**World Forum for Harmonization of Vehicle Regulations****Working Party on Passive Safety****Fifty-eighth session**

**Global technical regulation No. 7 (Head restraints)****Draft amendment 1 (Phase 2 of the global technical Regulation)****Submitted by the informal working group on the Phase 2 of the global technical regulation No. 7\***

The text reproduced below was prepared by the experts of the informal working group on global technical regulation No. 7 Phase 2 (GTR7-PH2) and proposes provisions on head restraints. The modifications to the text of the global technical regulation (ECE/TRANS/180/Add.7) are marked in bold for new or strikethrough for deleted characters.

Figure 1-1 [Goniometry in the test procedure using apparatus that facilitate the measurement of coordinates.]

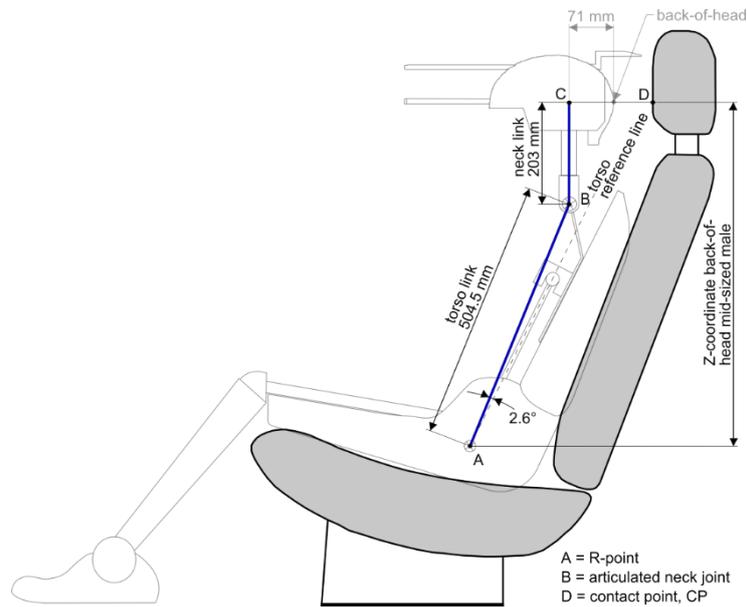
**Determination of contact point (CP) (see Figure 1-1)**

**The CP is defined as the intersection of a horizontal line, on the height of the Z-coordinate of the back-of-head of the mid-sized male (as given in table 1), with the front surface of the head restraint as indicated in Figure 1-1.**

<sup>1</sup> [The back-of-head of the mid-sized male is represented by the HRMD attached to the three-dimensional H-point machine, as well as by the Torso & Neck Link with the head room probe fitted 71 mm rearwards (see Figure 1-1)]

Figure 1-2

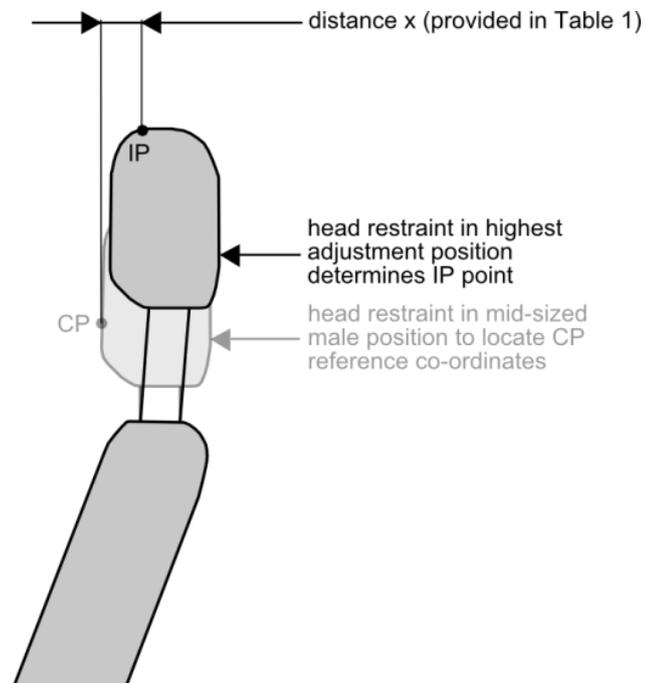
**The IP is determined on the front surface of the head restraint as the intersection with a vertical line rearwards of CP (see Figure 1-2) at the "distance x" (as given in table 1).**

Figure 1-3

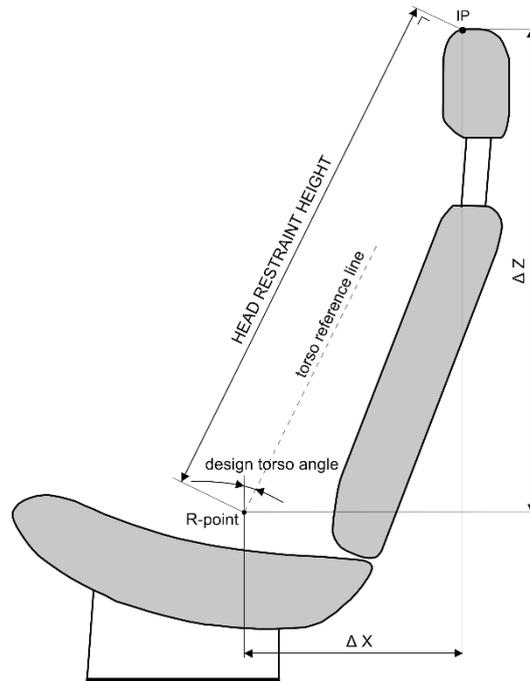
The head restraint height is the distance from the R-point, parallel to the torso reference line and limited by a line perpendicular to the torso reference line intersecting IP (see Figure 1-3).

After the coordinates of IP are determined, the highest head restraint height can be calculated by its longitudinal ( $\Delta X$ ) and vertical ( $\Delta Z$ ) distance from the R-point (see Figure 1-3), as follows:

Figure 1-4

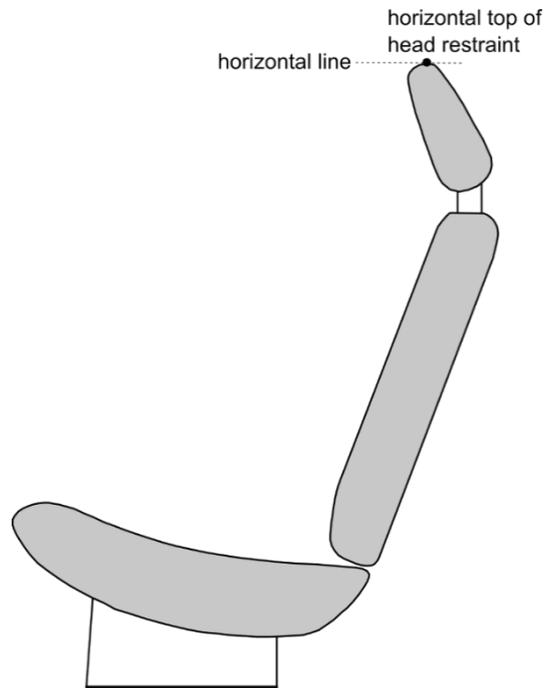
**Where IP would be located rearwards of the [horizontal top] of the head restraint, IP will be designated at the horizontal top of the head restraint (see Figure 1-4).**

Figure 1-5

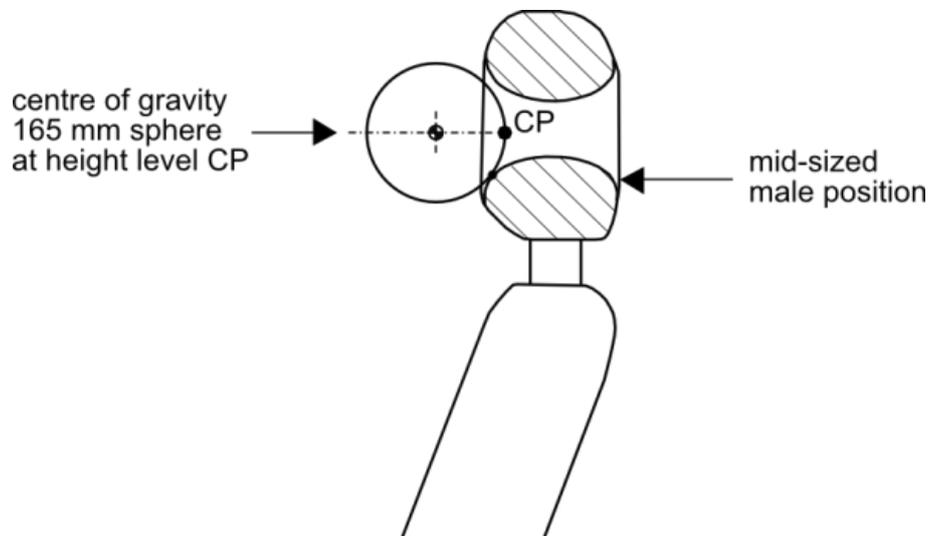
When the sphere is making first contact with the head restraint, CP is designated as the rearmost point of the sphere in the gap area (see Figure 1-5).

Figure 5-2

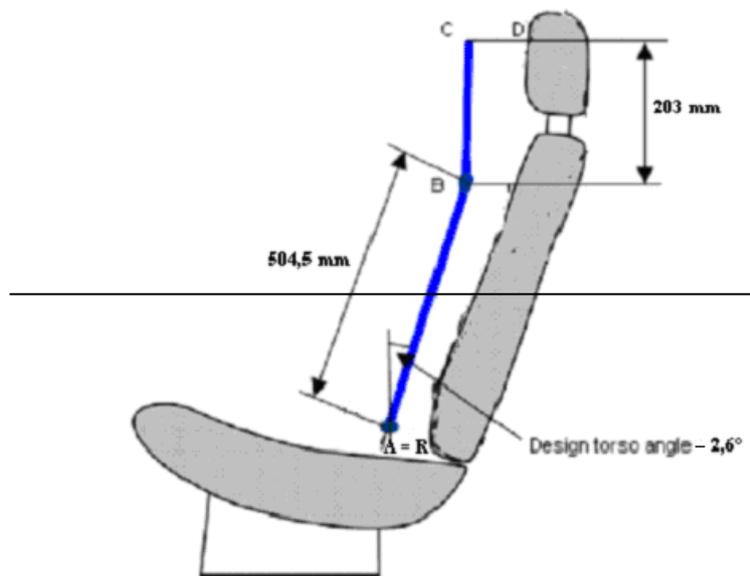
- ~~2.1. Backset measuring apparatus~~  
~~The backset measurement apparatus consists of (see Figure 5-2):~~
    - ~~2.1.1. A straight edge (lower arm) AB. The lower point A is placed at the R-point location. Point B is located at a distance of 504.5 mm from the R-point. The line AB is 2.6 degrees forward of the design torso angle.~~

- 2.3. Adjust the front head restraint so that its ~~top~~ **point IP** is at any height between and inclusive [750] [720]mm and 800 mm of paragraph [5.1.5.2.] of this Regulation, measured as described in Annex 1. If the lowest position of adjustment is above 800mm, adjust the head restraint to that lowest position of adjustment.
- 2.4. In the case of head restraint with adjustable backset, adjust the head restraint at the most rearward position, such that the backset is in the maximum position.
- 2.5. Establish point D on the head restraint, point D being the intersection of a line drawn from point C horizontally in the x-direction, with the front surface of the head restraint, see Figure 1-1 of Annex 1.
- 2.6. ~~Measure the distance CD. The backset is the measured distance CD minus 71 mm~~

**Measure the X-coordinate of point D. The R-point backset is the difference between the X-coordinate of point D and the X-coordinate of the back-of-head of the mid-size male as given in Table 1 of Annex 1.**

Figure [X]

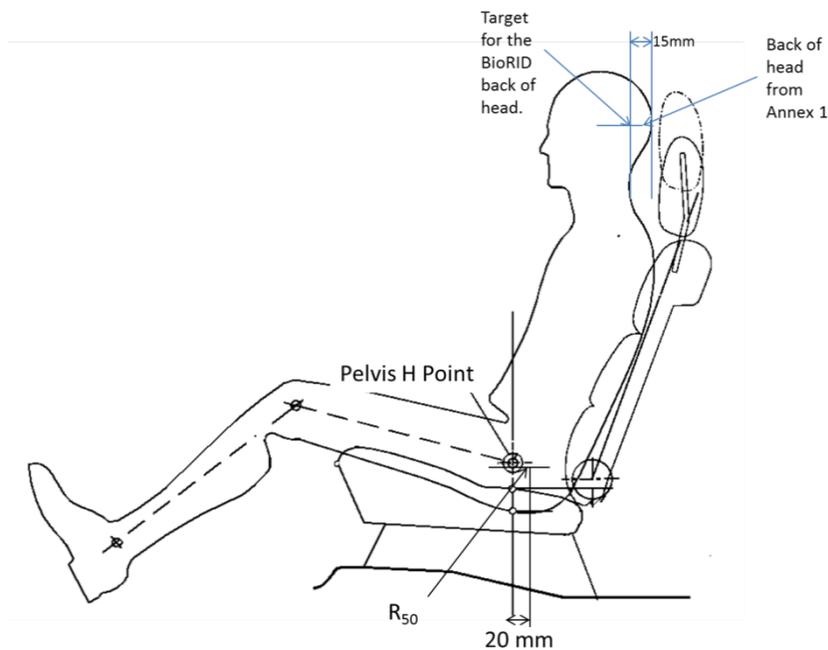
The back of the head reference position for the BioRID II UN is the value for the back of the head as determined for the 50 percentile in table 1 annex 1 of this Regulation with reference to the specified torso angle minus 15 mm (increasing the backset as shown in figure x *below*).

**Figure 9-2**  
Acceleration versus time curve and Permissible Range of curve for the test set-up according to section 3.2. (The target acceleration with time expressed in milliseconds shall meet the value in the table 9-3.)

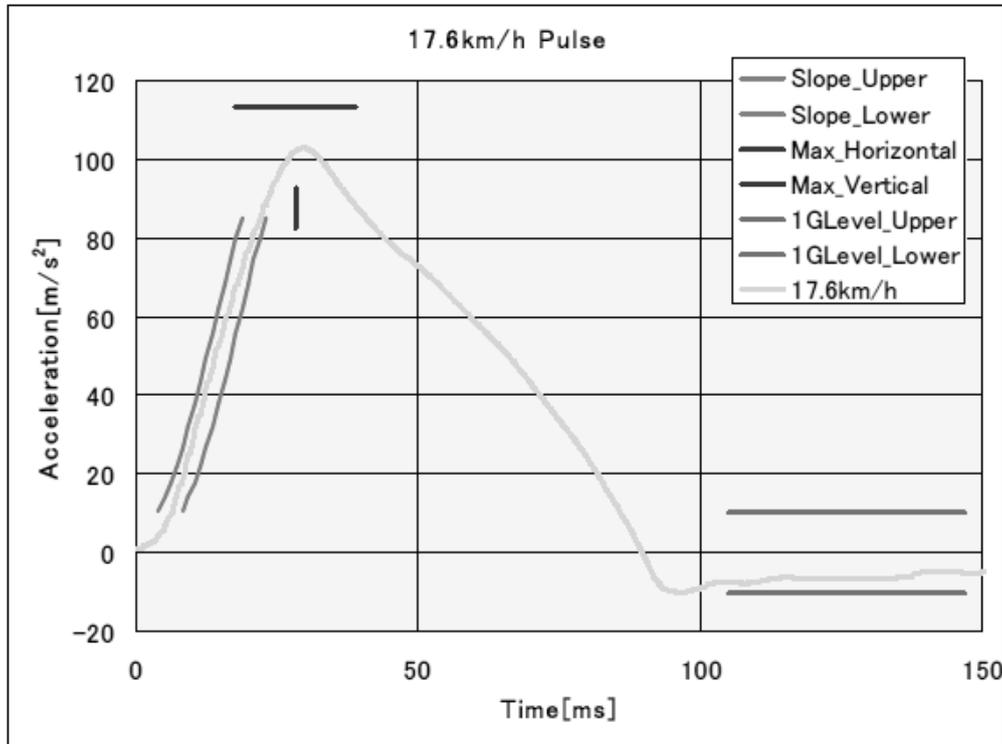
The corridors for the pulse are illustrated in Figure 9-3. [The sled acceleration shall be adjusted within the corridors described in Figure 9-2 and Table 9-2 for the complete time interval from 0 to 0.15s.] The sled pulse shall fulfil the requirements as specified in Table 9-3.

**Table 9-3**  
**Sled pulse corridor reference point locations in Figure 9.2.**
